## Summary for DRH18-00260

Rafanelli & Nahas – Scott Schoenherr, requests Design Review approval to Construct a ten story, approximately 181,000-square feet, office building and other site related improvements within the R- C-5DD (Central Business with Downtown Design Review Overlays) zone. The site is located within the heart of the downtown core. 11th Street and Idaho Street are designated as “Storefront” street frontages within the Downtown Boise Design Review Standards and Guidelines. The Idaho Street and 11th Street intersection is identified as a “Gateway and High Visibility Street Corner” in the Downtown Boise Design Review Standards and Guidelines.

# Planning Division Project Report

<b>File Number</b>	DRH18-00260
<b>Applicant</b>	Rafanelli & Nahas – Scott Schoenherr
<b>Property Address</b>	1118 West Idaho Street
<b>Public Hearing Date</b>	July 11, 2018
<b>Heard by</b>	Design Review Committee
<b>Design Review Planner</b>	Andrea N. Tuning
<b>Design Review Supervisor</b>	Hal Simmons

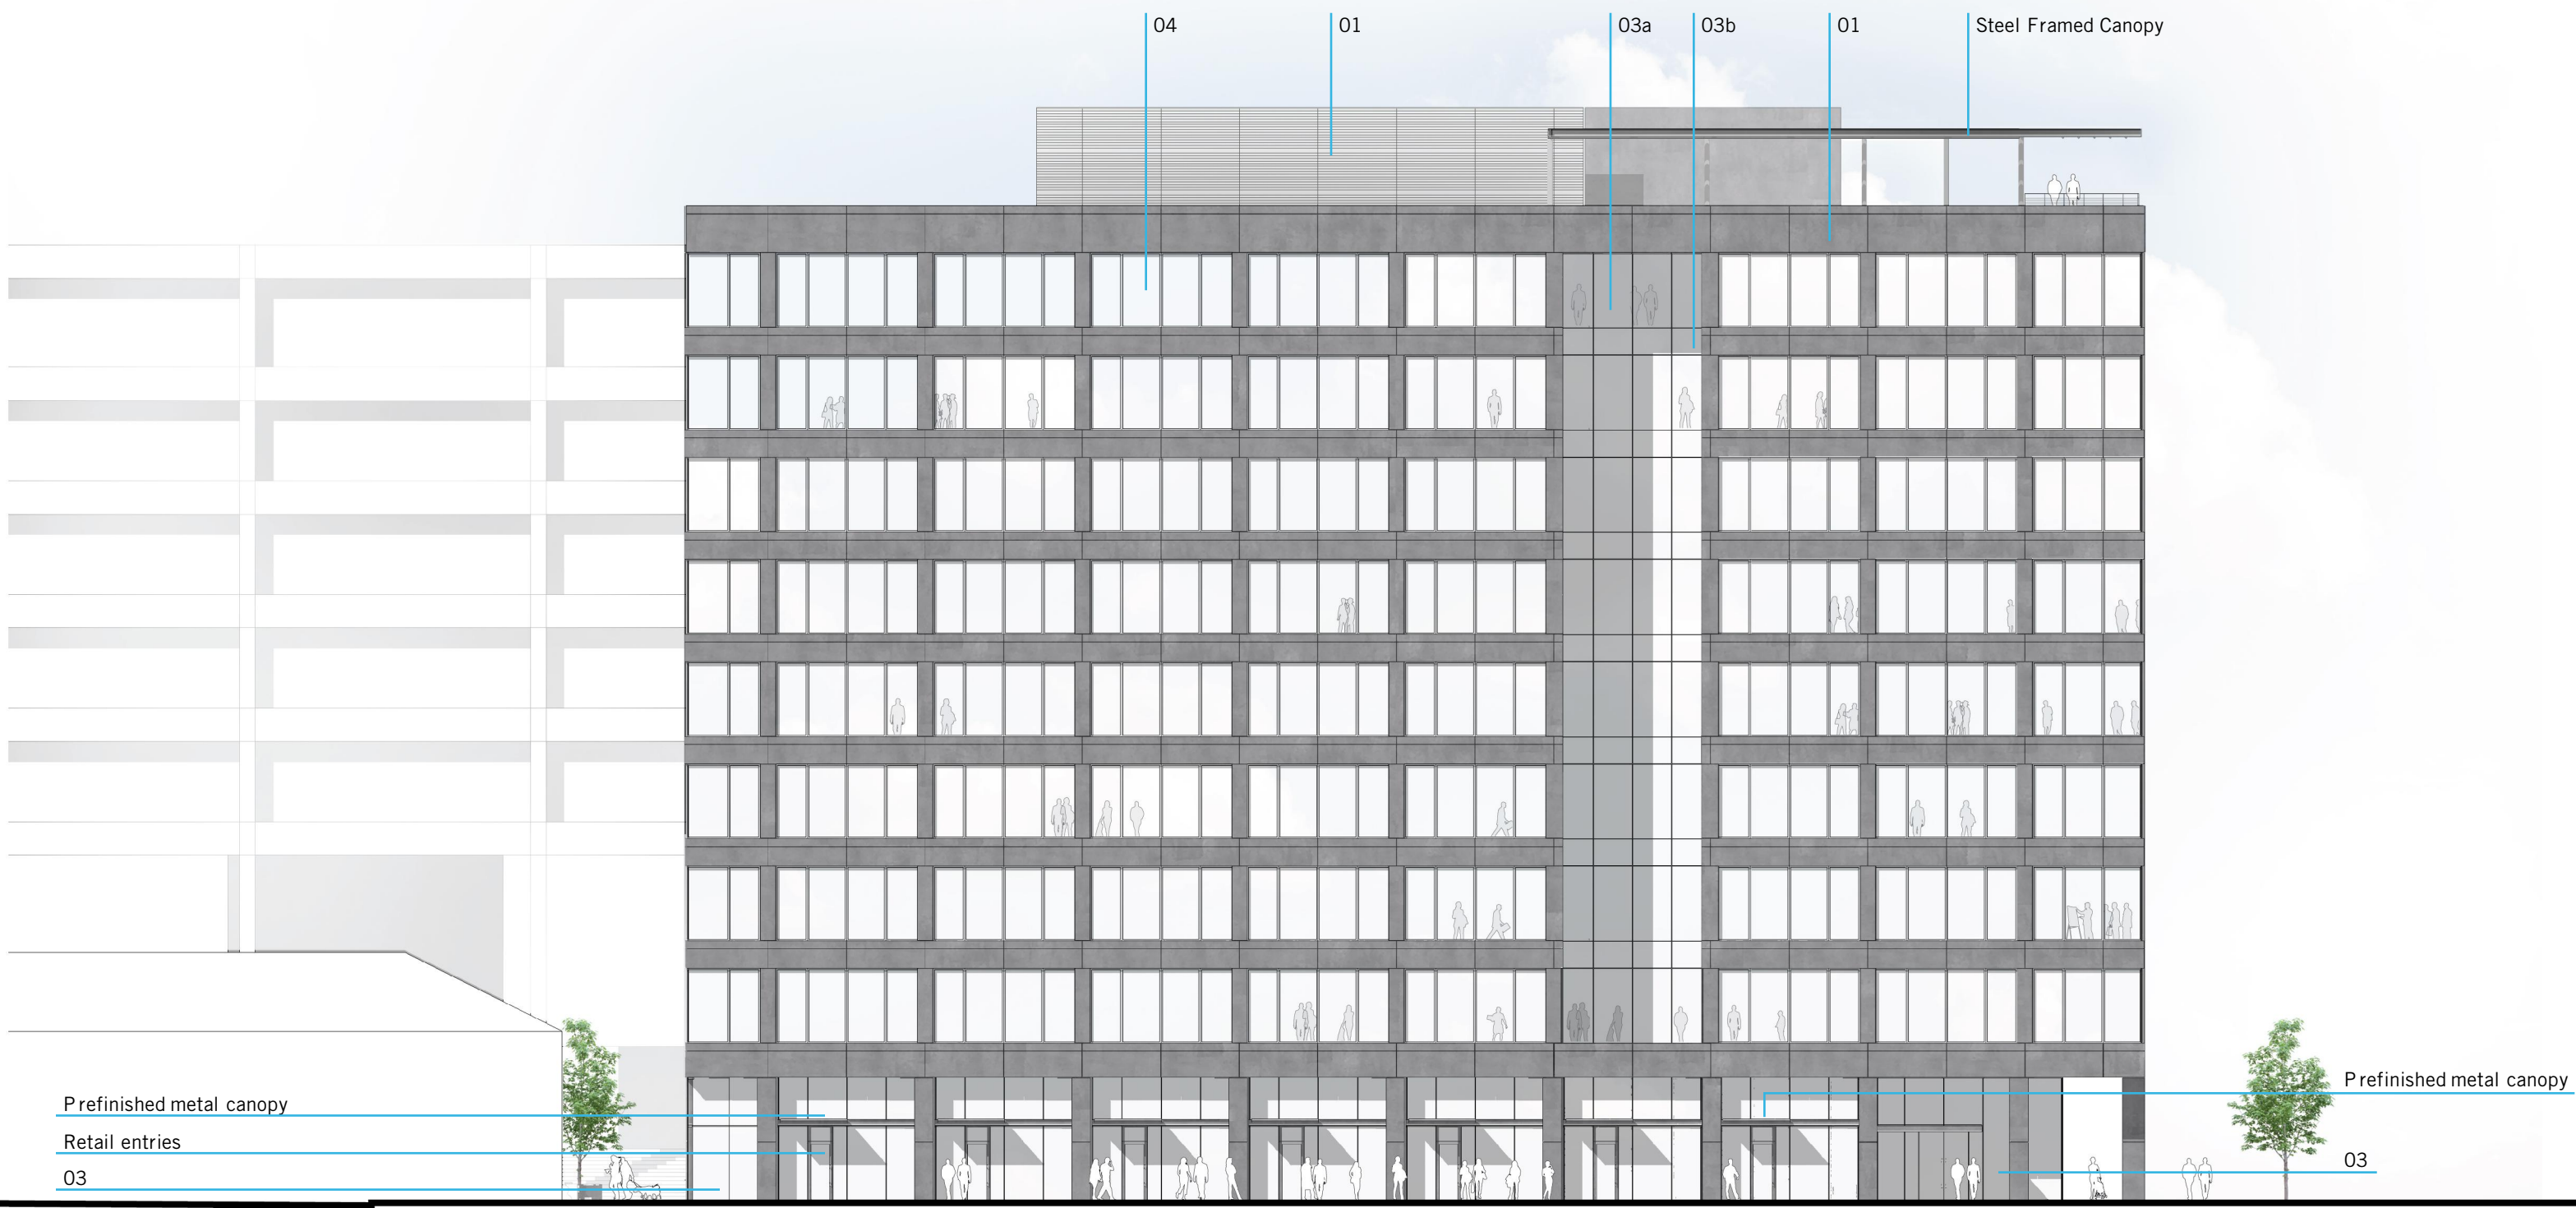
The Design Review Division has recommended the applicant make minor modifications to the street improvements, increase the depth of the ground floor canopies, widen the overhead door on the west elevation, provide an easement for trash servicing, provide full height mechanical screening and obtain a license agreement for the canopies. With the recommended conditions of approval, the 10-story mixed-use building will contain appropriate colors and materials, fenestration, and articulation.
